Aircraft Design Certification GmbH Reichensteinstr.48 69151 Neckargemünd		Update tow winch system installation	Doc-Nr: ADxC-73-SB-036 Issue: A Date: 27.06.2023 ChangeNr.: ADxC-DC-73-100
Service Bulletin

Update tow winch system installation
SERVICE BULLETIN

<p>Update tow winch system installation</p> <p>Optional update of the tow winch system</p> <ul style="list-style-type: none"> -Change of guillotine control handle surface to be knurled -Retrofit of a tail skid to the tow winch system at rear fuselage

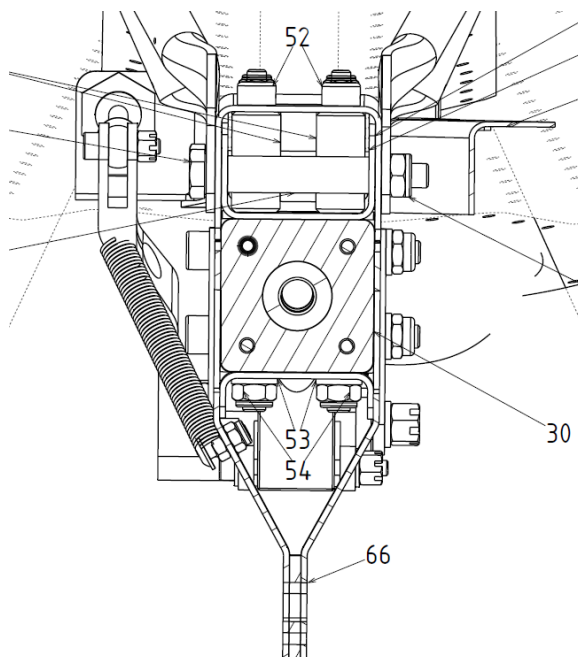
- 1) Tail skid installation
 - a) Dismount old bracket holding the return spring. See figure below, red ellipse: bracket to be replaced, seen from below.

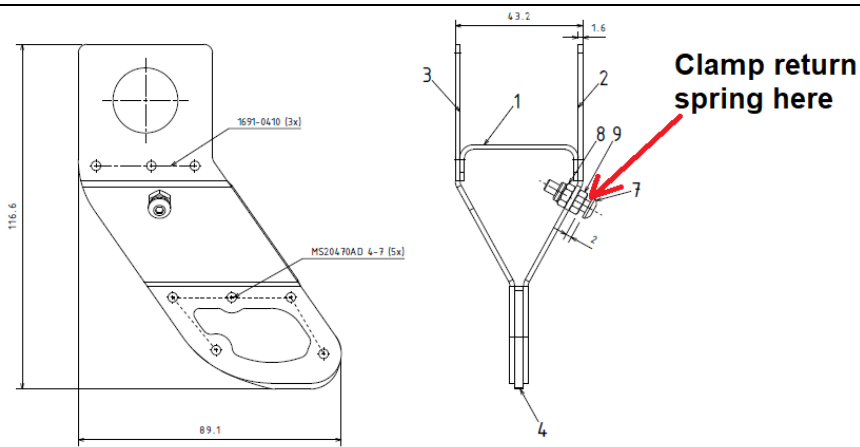
- b) See figure below, the fasteners [2 x bolts (52), 2 x washers (53), 2 x self-locking nuts (54)] can be reused. Now, their installation direction swapped versus the unchanged design.

- c) Mount Tail skid.
 - d) Mount return spring. See figure below, it must be clamped between screw (7) and nut (9). Self-locking nut must be then tightened.
